## DOCUMENT CHANGE REQUEST

DCR number 250

Title: Connector Savers Electrical Rectangular Miniature Removable Contacts, based on type D\*BMA

Number: 3401/020

Plug Contact Cavity Arrangements — High Density

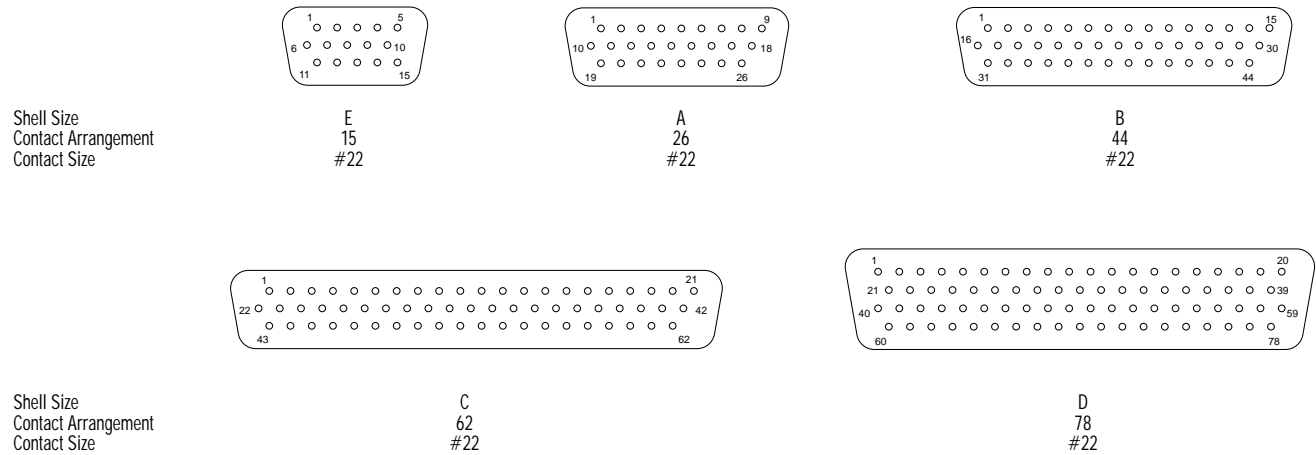
Page 9, Figure 2(b), VARIANT 02-...

In figure 2(b) is presented the contact layout of D-connector 78 Contact, Gauge 22. The contact layout/numbering is incorrect. In picture there are presented incorrectly 79 contacts.

Correct contact layout presented in attachment.
